construction bid document addendum 01

project: Aroostook State Park - Shower-Restroom Building & Utility Improvements
Presque Isle, Aroostook County, Maine BGS # 3492

date: 29 October 2024

items: GENERAL - Responses to Pre Bid Conference Questions

10 FLOOR PLAN
1/4" = 1'-0" [NEW BLDG 1204 GSF]

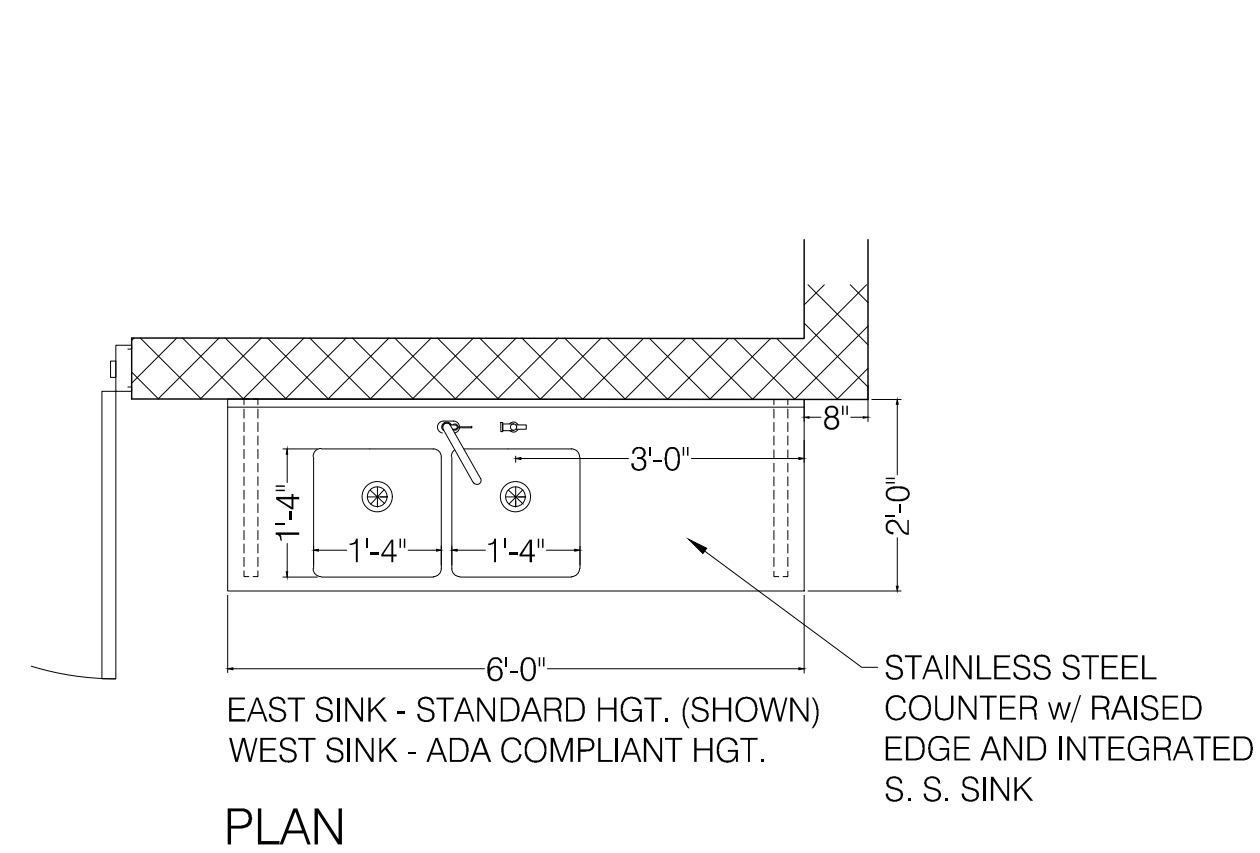
- A10 SHOWER BUILDING - FLOOR PLAN: ADD concrete slab 8 inches into mechanical chase see SHEET S1.1 for location. Revise exterior hose bibs to locations shown on SHEET M20 and revised on A20 EXTERIOR ELEVATIONS.
- A11 SHOWER BUILDING - ENLARGED PLANS & DETAILS: ADD steel angle brackets and fastener details for wood timber benches.
- A20 SHOWER BUILDING - EXTERIOR ELEVATIONS: Revised hose bib locations.
- A41 SHOWER BUILDING - WALL SECTIONS: Updated column base and top connector detail. See Structural for additional information.
- A40, A41 & A42 SHOWER BUILDING - WALL SECTIONS. All details showing high density rigid insulation under the concrete foundation and slab are to be the size and type noted on Structural Drawings.
